**AMENDMENTS TO THE DRAWINGS**

Please replace sheets 4, 5, and 6 of the drawings on record, which include Figs. 4b, 5a, and 5b, respectively, with the replacement sheets 4, 5, and 6 enclosed herewith.

Figure 4b

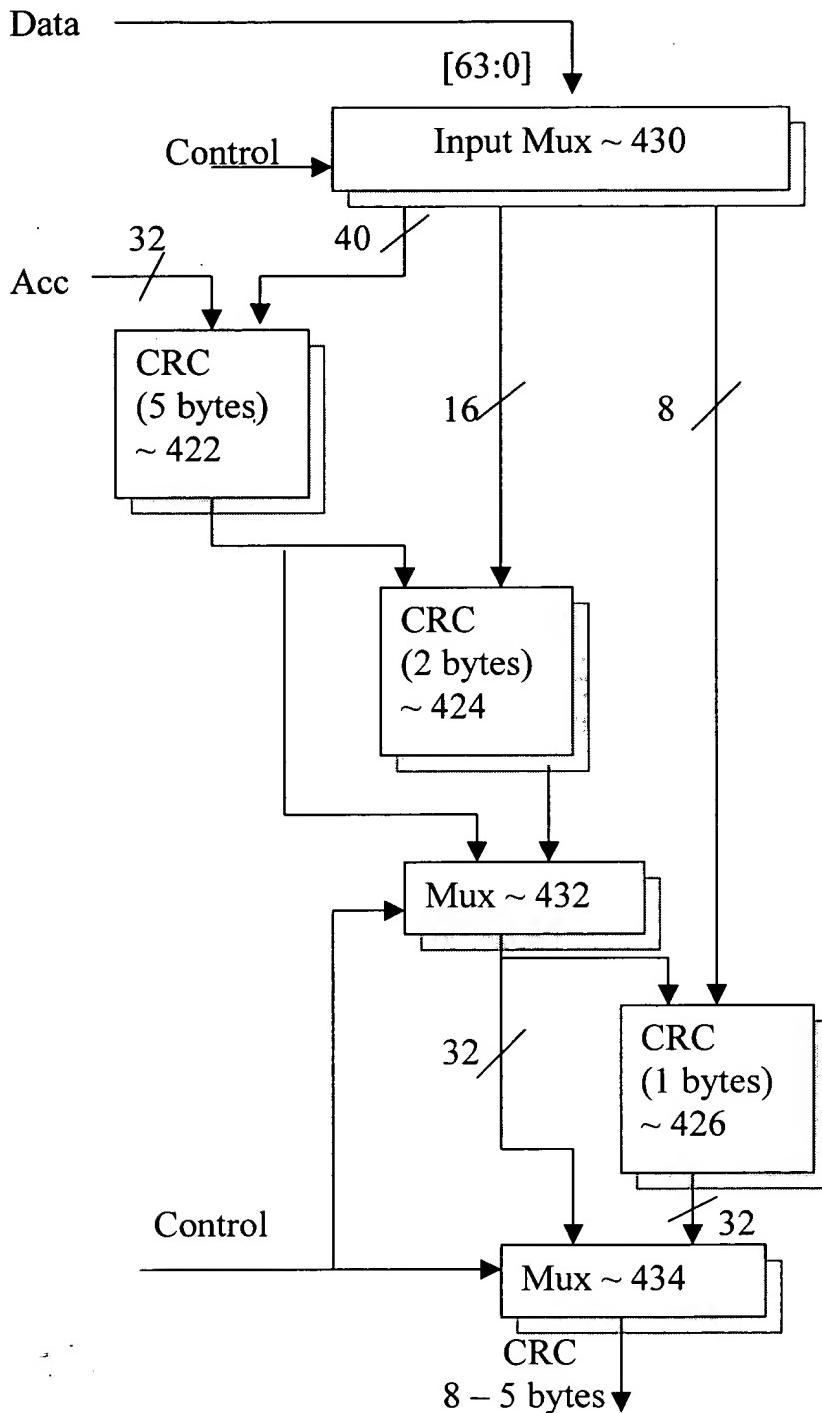
In Fig. 4b, the input bit distribution has been changed from “[64:0]” to “[63:0]”.

**Figure 5a**

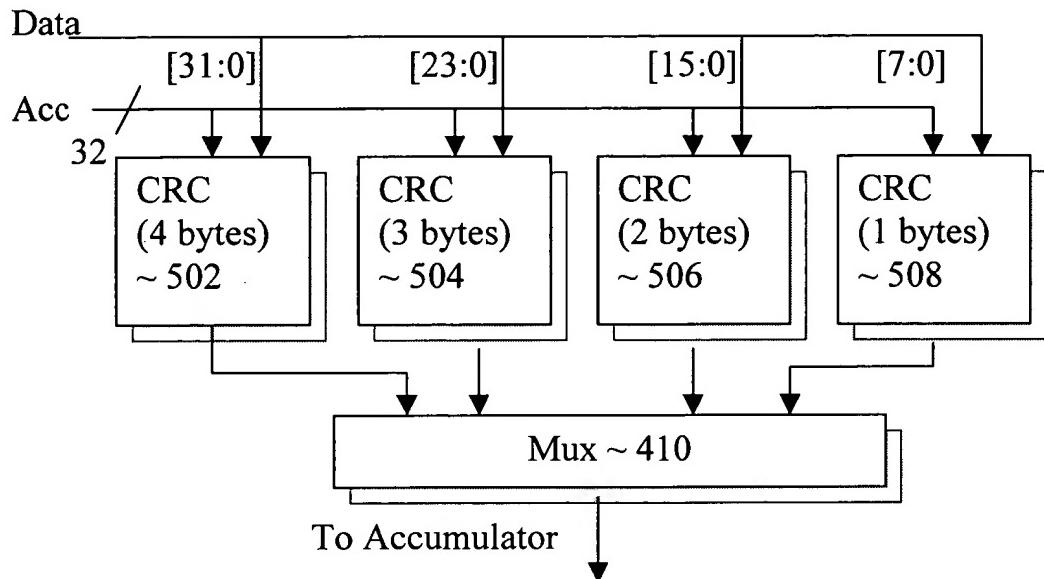
In Fig. 5a, the input bit distributions have been changed from “[63:0]”, “[56:0]”, “[48:0]”, and “[40:0]” to “[31:0]”, “[23:0]”, “[15:0]”, and “[7:0]”, respectively.

Figure 5b

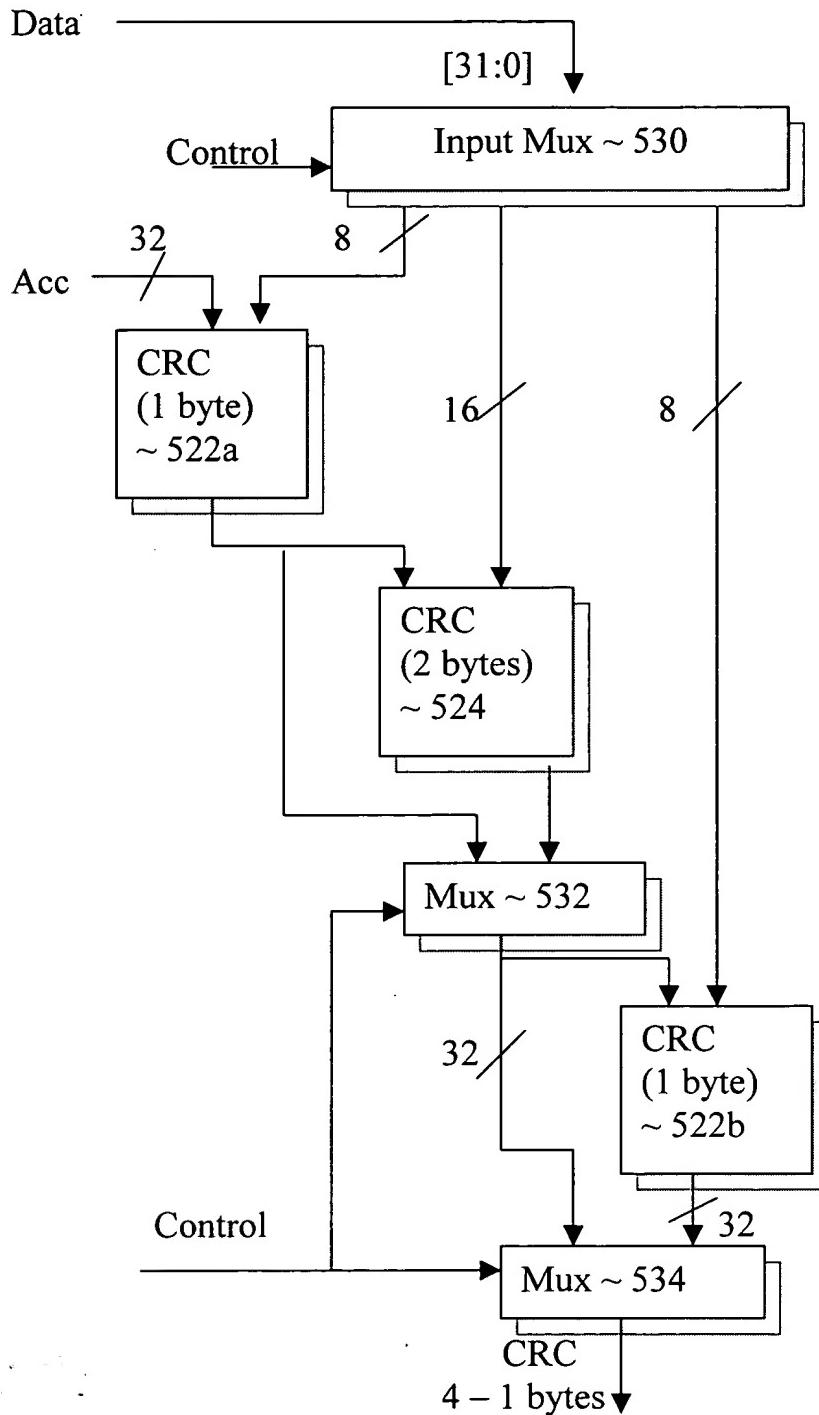
In Fig. 5b the input bit distribution has been changed from “[64:0]” to “[31:0]” and the bit capacity of the line from 530 to 522a has been changed from “40” to “8”.
